DOCKETED	
Docket Number:	23-OPT-01
Project Title:	Fountain Wind Project
TN #:	257471
Document Title:	fwp_well_location_memo
Description:	N/A
Filer:	Caitlin Barns
Organization:	Stantec Consulting Services, Inc.
Submitter Role:	Applicant Consultant
Submission Date:	6/27/2024 1:28:30 PM
Docketed Date:	6/27/2024

To:	Lon Payne	From:	Caitlin Barns
	California Energy Commission		Stantec Consulting Services, Inc.
Project/File:	Fountain Wind Project	Date:	June 27, 2024

Reference: Updated Water Supply Information for Fountain Wind Project

APPLICANT RESPONSE TO CEC DATA REQUEST WATER-5:

Figure 1. Location of Hat Creek Construction property (blue star) on which the three wells proposed to supply Project construction water are located compared to the locations of the three adjacent groundwater basin boundaries (Goose Valley, Burney Creek Valley, and Lake Britton, circled in red).

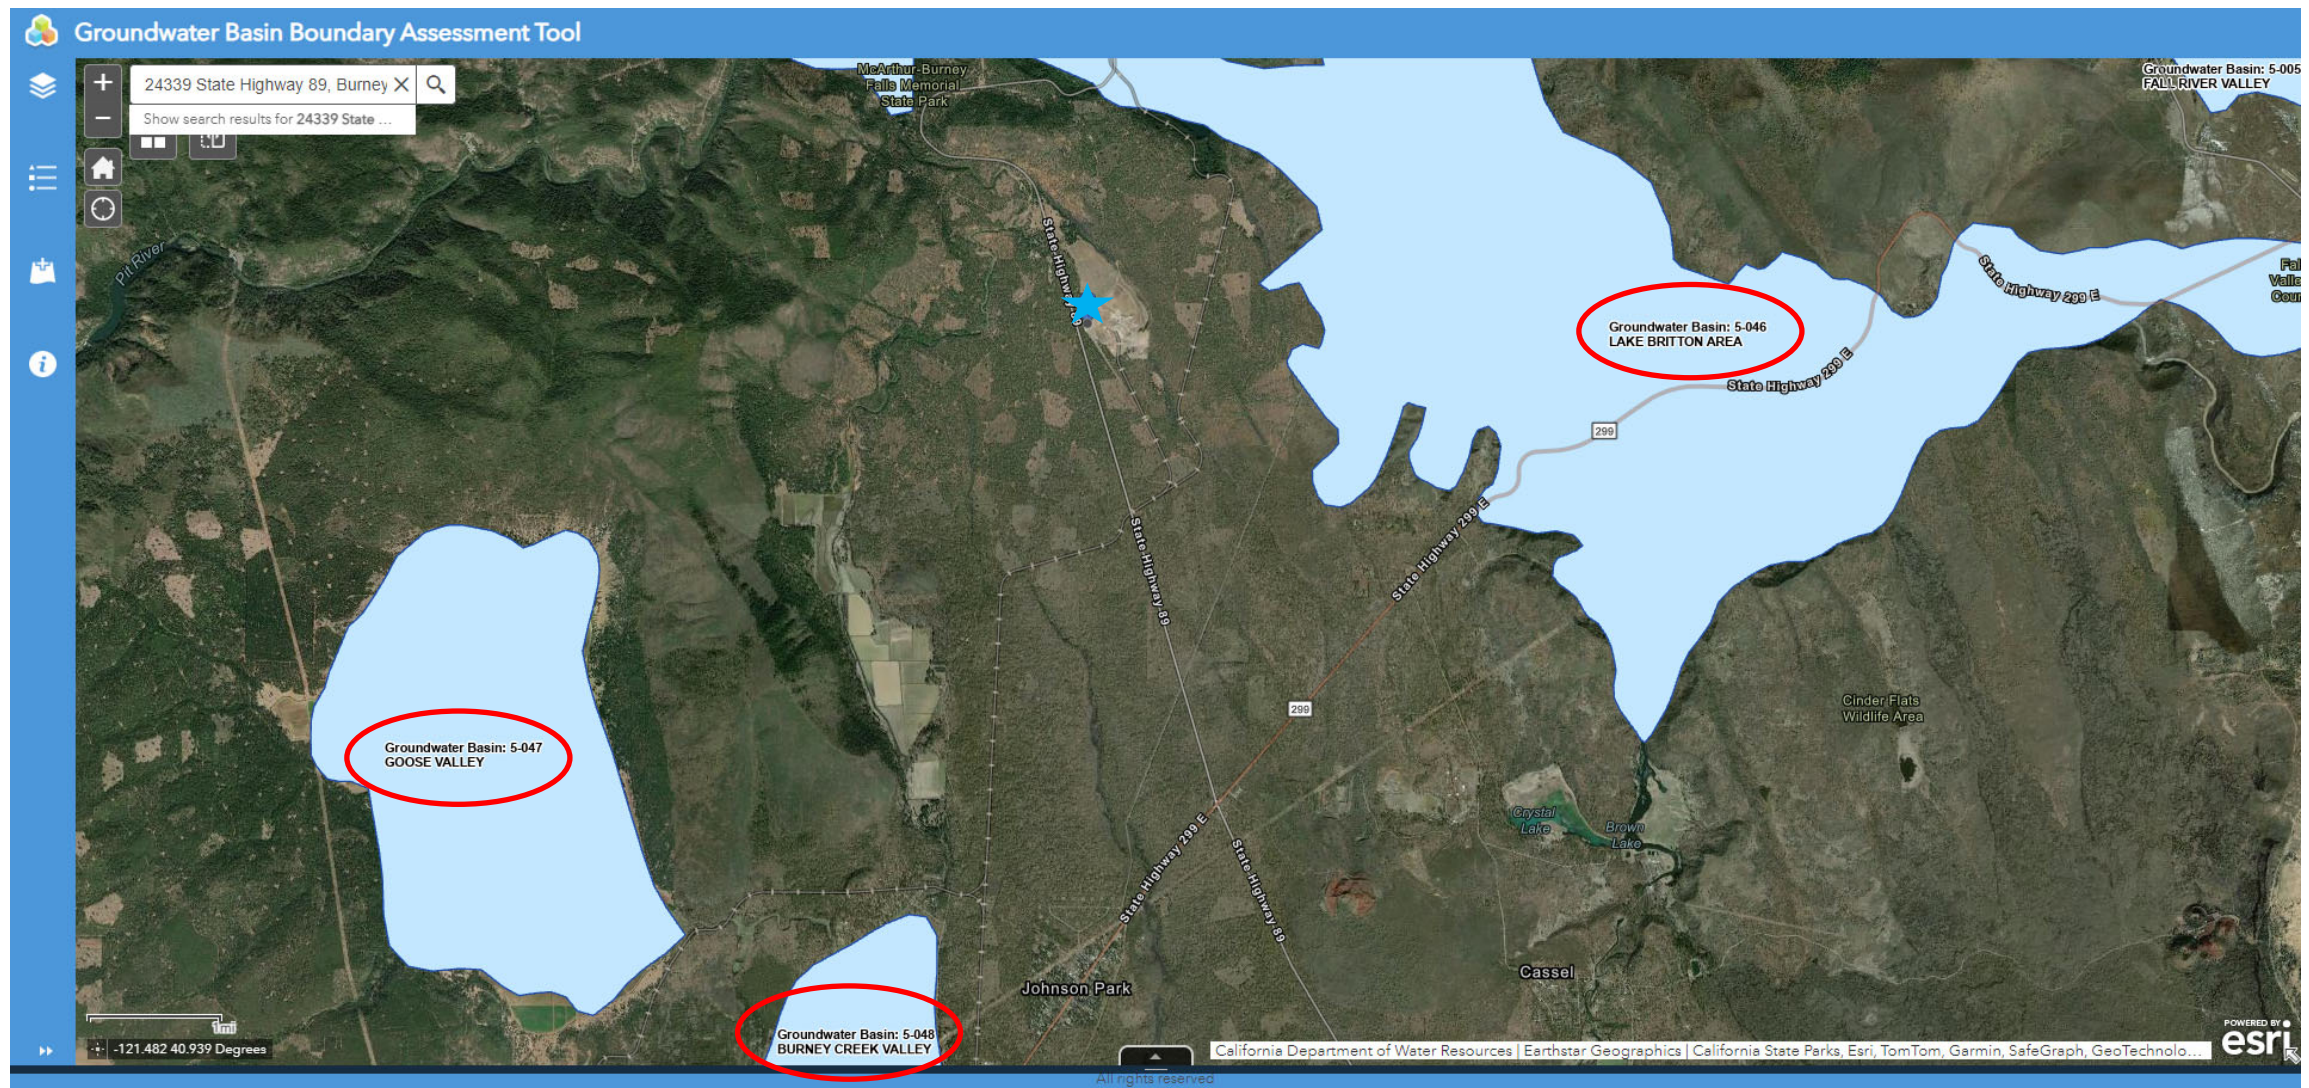
WATER-5: Please provide documentation to verify that the groundwater extraction wells are located in the Burney Creek Valley groundwater basin. If these wells are located at the HCC facility, please revise the Water Supply Report to include an evaluation of the Lake Britton Area groundwater basin."

The Hat Creek Construction (HCC) property is located at 24339 CA Hwy 89 Burney, CA 96013 and the three wells proposed to supply the Fountain Wind Project during construction are located at this address. Since docketing the latest revision of the Water Supply Report, the applicant has confirmed with HCC that those three wells are located on the property at that address. The property is located outside the Burney Creek Valley Groundwater Basin (approximately 4.6 miles northeast) and outside the Lake Britton Groundwater Basin (approximately 1.3 miles west)(see Figure 1).

Based on analysis by Stantec hydrogeologist Thomas Regan (resume in Appendix A), HCC's wells withdraw groundwater from one or more fractured volcanic rock aquifers beneath the property (Figure 1), separated from the Lake Britton Area and Burney Creek Valley groundwater basins by numerous faults (Figure 2) including the Holocene active Rocky Ledge fault zone which borders the HCC property on the east and unnamed Holocene active faults on the west¹. These faults collectively act as barriers to groundwater flow and laterally confine the underlying aquifer along these geologic structures. The aquifer underlying the HCC property and adjacent area is not located within a Department of Water Resources (DWR) Bulletin 118-designated groundwater basin. As described in the Water Supply Report (TN 256385), aquifers such as this one do not meet the threshold for prioritization under California Statewide Groundwater Elevation Monitoring or the Sustainable Groundwater Management Act. As a result, groundwater elevation monitoring and preparation of a Groundwater Sustainability Plan are not required. As a result, aquifer characterization and groundwater level data are generally lacking with the exception of well completion reports.
